Summary

System Software v4.4.0 Update

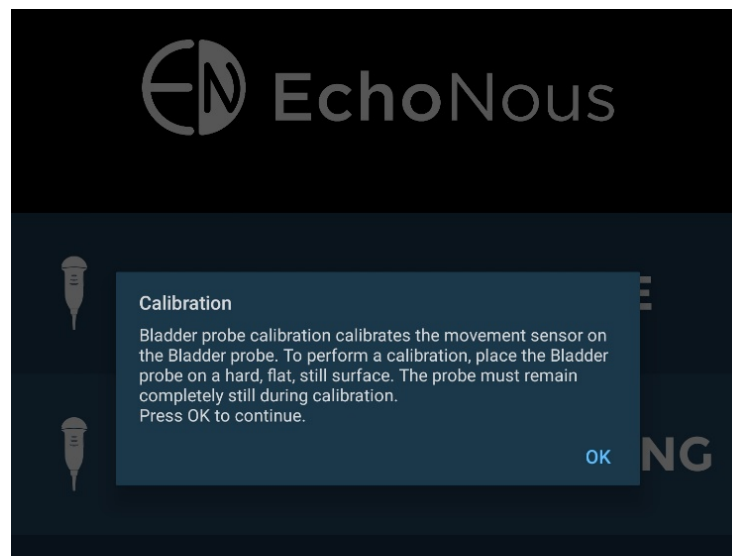
- ◇ The 4.4.0 software continues to store the probe calibration data in the tablet. This means that when a new (unknown) Bladder Probe is connected to the Tablet, the Tablet will require a calibration be performed before initial use.
- ◇ The request to calibrate will take the form of the image below.
 - The request to calibrate an unknown Bladder Probe will ‘time out’ after 10 seconds if the ‘OK’ is not pressed.
 - If the calibration requirement times out before pressing OK, back out of the menu and navigate to Three Dots -> Settings -> Maintenance -> Bladder Probe Calibration, follow instructions and tap OK.
